Groundwater Flow Model of the General Separations Area Using PORFLOW

WSRC-TR-2004-00106
Revision 0

**GROUNDWATER FLOW MODEL OF THE
GENERAL SEPARATIONS AREA USING PORFLOW (U)**

APPENDIX B – DESIGN CHECKING COMMENTS AND RESPONSES/RESOLUTIONS.

Figure 2-6. Cross-sectional view of horizontal hydraulic conductivity field for (a) FACT, and (b) PORFLOW.

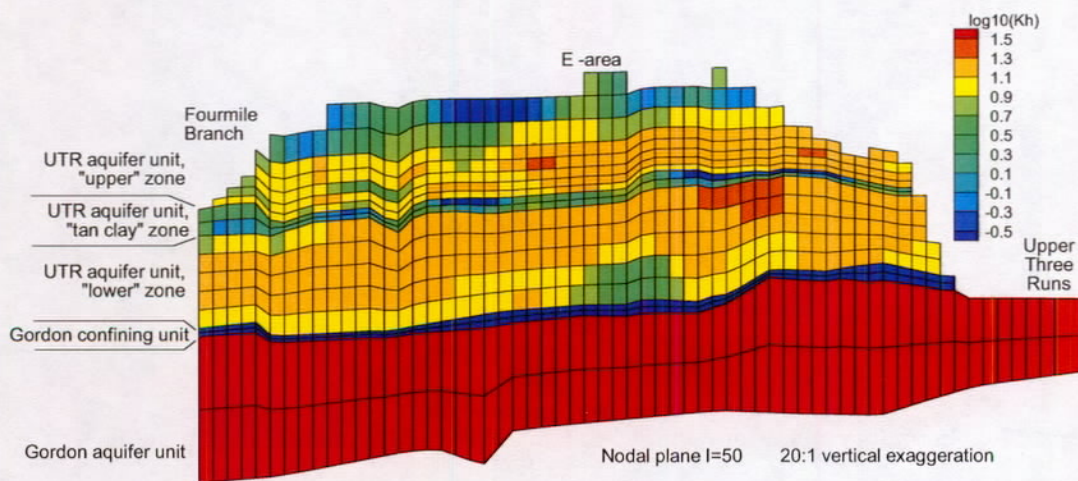
#	Section/Page/ Paragraph/Line	Comment	Reviewer Initial	Response/Resolution	Reviewer Concur	
23	Page 6/S2.5/P2	How much longer were the travel times computed by PORFLOW? What was the cause for the differences, other than recharge flux?		A quantitative comparison of travel times was not done - just visual. Differences in the vertical grids and conductivity fields apparently caused some difference in flow direction and speed. Also differences in spatial averaging/interpolation of the K field by the two codes had an impact	Yes	
24	Page 6/S2.5	The changes in conductivity values relative to the GSA/FACT model for the three zones described seem pretty large. Is that an artifact of the geometric averaging of hydraulic conductivities used in PORFLOW?		Differences were larger than anticipated. Seems to be a result of the factors mentioned in #23	Yes	
25	Page 11	In Figure 2-6 do you mean "horizontal" or "vertical"?		Horizontal as in Kh	Yes

Figure 2-8. Example velocity field showing predominantly downward flow in the vadose zone; vectors are fixed length showing flow direction only.

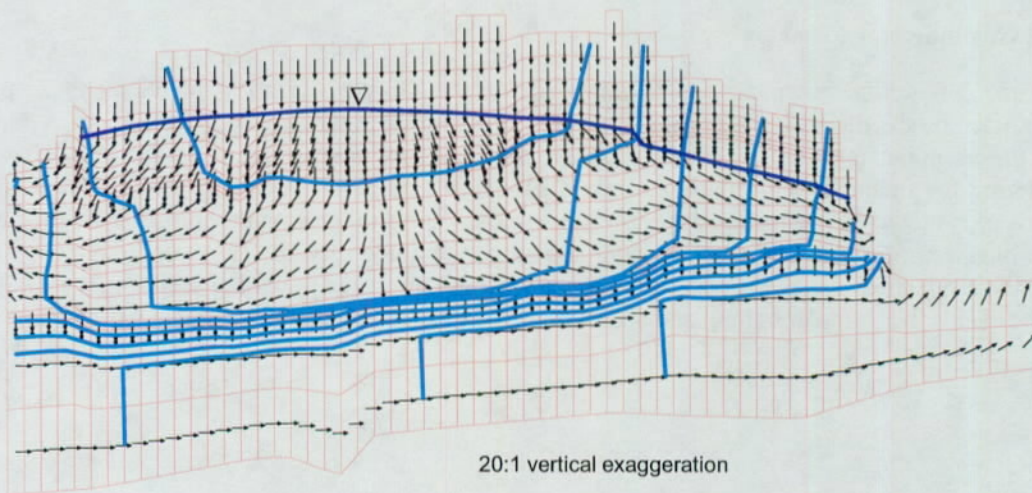
26	Page 12	In Figure 2-8 can you show a line that delineates the water table (red line)?		Water table marker added	Yes	
27	Page 13/S3.1	Add a Table 3-2 showing the summary statistics for the GSA/FACT model.		Provided in Table 4-4	Yes	
28	Page 13/S3.2	In your discussion, groundwater discharge corresponds to negative fluxes. In Figure 3-7, groundwater discharge areas are indicated by positive values.		Text corrected	Yes	
29	Page 14	Add a column to Table 3-2 showing the simulated stream baseflows for the GSA/FACT model.		Provided in Table 4-5	Yes	
30	Page 15	What is the significance of the model cross-section at I=50?		Caption revised to indicate slice through E Area	Yes	
31	Page 19	See Comment 28.		See Comment 28	Yes	
32	Page 20/S4.0	Verification and Validation activities should be addressed in the Software Quality Assurance Plan.		Agreed. The V&V tests performed within this project are now related to the PORFLOW Software QA Plan	Yes
